[Issue No.] FA-A-0066-A	[Page] 1/4
[Title] Precautions for external wiring of safety input	(X0, X1)
[Date of Issue] July 2009 (Ver. A: March 2010)	
[Relevant Models] QS90SR2SN-Q, QS90SR2SP-Q	, QS90SR2SN-CC, QS90SR2SP-CC,
QS90SR2SN-EX, QS90SR2SP-	EX

This technical bulletin gives additional precautions for external wiring in a system where any extension safety relay module is used. Please use safety relay modules in accordance with the precautions given in this bulletin.

Figure 1 System configuration and external wiring diagram

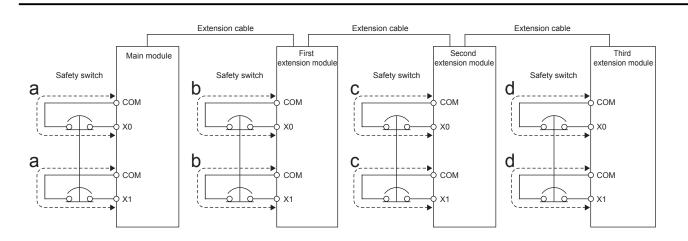
*2: Each wire length (a, b, c, and d) corresponds to the same alphabets shown in Figure 1.

*2: Each wire length (a, b, c, and d) corresponds to the same alphabets shown in Figure 1.

*2: Each wire length (a, b, c, and d) corresponds to the same alphabets shown in Figure 1.

- a: External wire length of the safety input (X0-COM, X1-COM) of the main module
- b: External wire length of the safety input (X0-COM, X1-COM) of the first extension module
- c: External wire length of the safety input (X0-COM, X1-COM) of the second extension module
- d: External wire length of the safety input (X0-COM, X1-COM) of the third extension module
